Agenda Item #: 4 SUB-002746-2023

Cottage Hill Heights Subdivision, Resubdivision of Lots 1 & 2

- Subdivision approval to create three (3) legal lots of record from two (2) existing metes-and-bounds parcels.

APPLICATION NUMBER 4 DATE December 21, 2023

DETAIL SITE PLAN

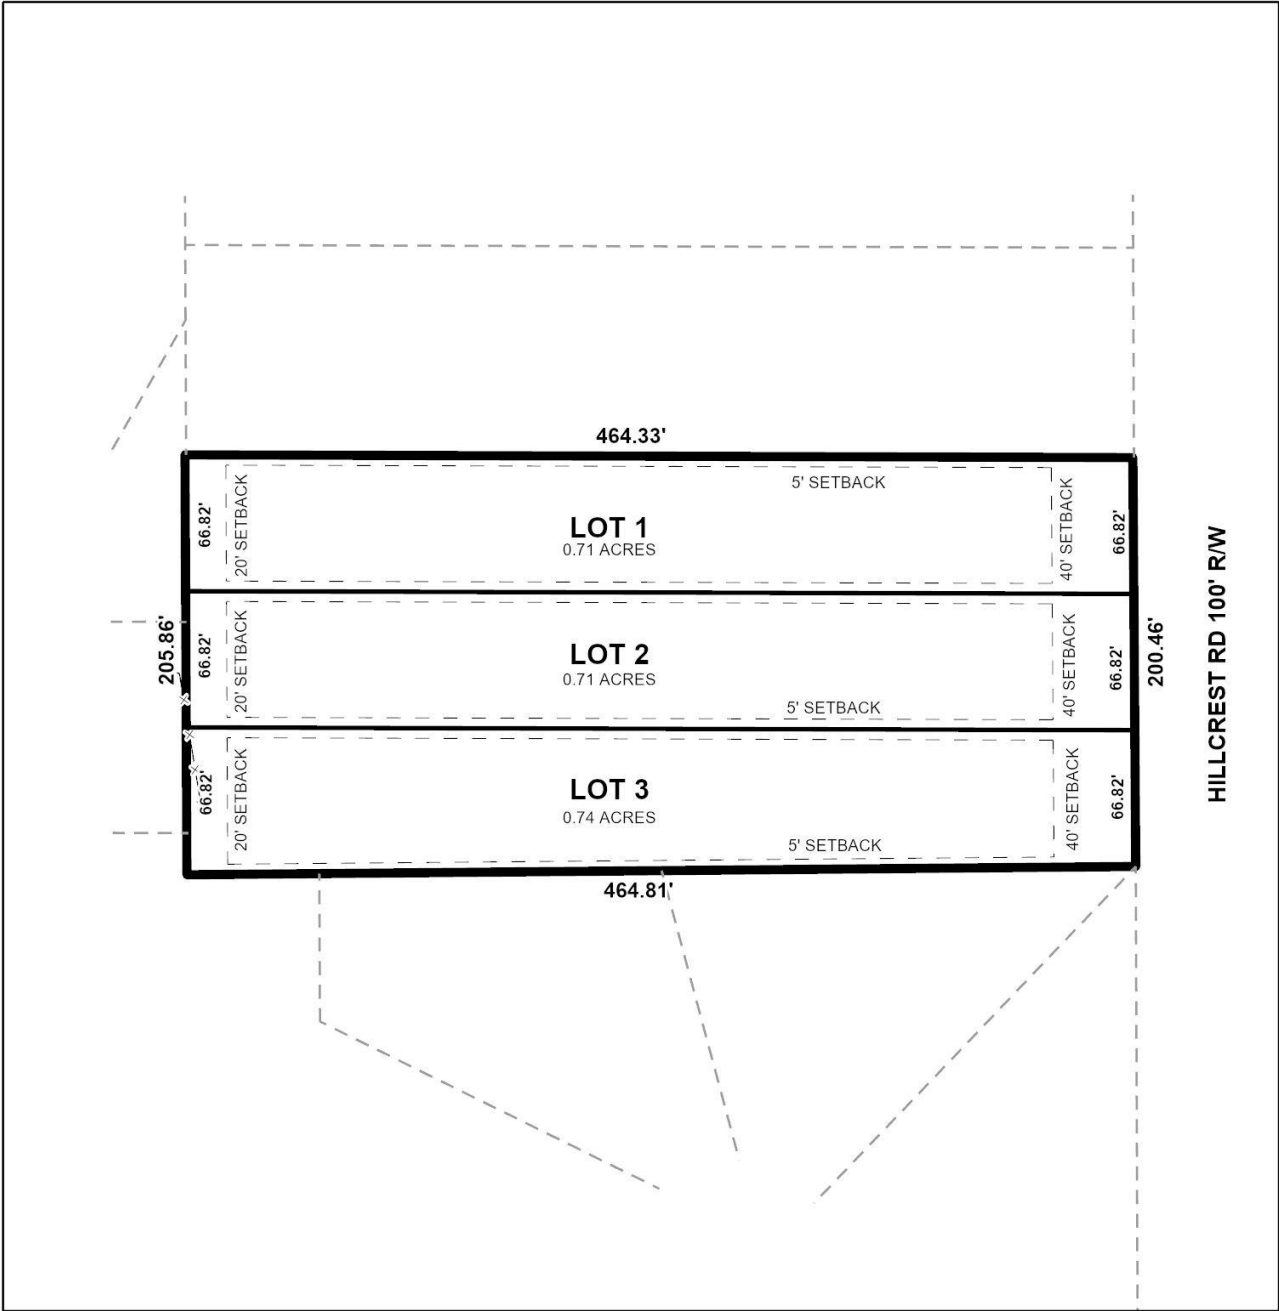
Proposed Lots 1, 2, and 3 all have frontage on Hillcrest Road, a Major street on the Major Street Plan equipped with curb and gutter requiring a 100-foot right-of-way. The preliminary Plat illustrates a compliant right-of-way width which, if approved, should be retained on the Final Plat.

The proposed lots exceed the minimum size requirements of Article 2, Section 64-2-6 of the UDC for lots in an R-2, Two-Family Residential Suburban District and are appropriately labeled in square feet and acres. If approved, this information should be retained on the Final Plat, or a table should be furnished on the Final Plat providing the same information.

The proposed lots are approximately seven (7) times longer than they are wide, and as such, exceed the maximum width-to-depth ratio of 3.5 times set by the Subdivision Regulations. This is not a common lot design within the surrounding neighborhood; however, with the exception of one lot to the South, which also doesn't comply with Section 6.C.3., these are the only residentially zoned lots on the West side of Hillcrest Road that also face Hillcrest Road, thus a waiver of Section 6.C.3. of the Subdivision Regulations may be appropriate.

The Preliminary Plat illustrates a 40-foot front yard setback along Hillcrest Road, 5-foot side yard setbacks, and a 20-foot rear yard setback for all three (3) lots. However, per Article 2 Section 64-2-6 of the UDC only a 25-foot front yard setback, 5-foot side yard setback, and 8-foot rear yard setbacks are required for lots in an R-2, Two-Family Residential Suburban District. Additionally, per Section 6.C.8. of the Subdivision Regulations only a front yard setback is required to be illustrated on a Final Plat. The applicant may retain the setbacks as illustrated, but if approved and the plat recorded in the Mobile County Probate Court depicts the setbacks as illustrated, future development of the properties will be subject to setbacks greater than what are required by the UDC. As such, at

least a 25-foot front yard setback should be illustrated along Hillcrest Road, and no side or rear setbacks should be illustrated on the Final Plat.

1. Retention of at least a 25-foot front yard setback along Hillcrest Road;
2. Removal of side or rear setbacks from the Final Plat;
3. Retention of a 100-foot right-of-way for Hillcrest Road on the Final Plat;
4. Retention of the Final Plat to depict lot size labels in both square feet and acres, or provision of a table on the Final Plat with the same information;
5. Compliance with all Engineering comments noted in this staff report;
6. Placement of a note on the Final Plat stating the Traffic Engineering comments noted in this staff report;
7. Compliance with all Urban Forestry comments noted in this staff report; and
8. Compliance with all Fire Department comments noted in this staff report.
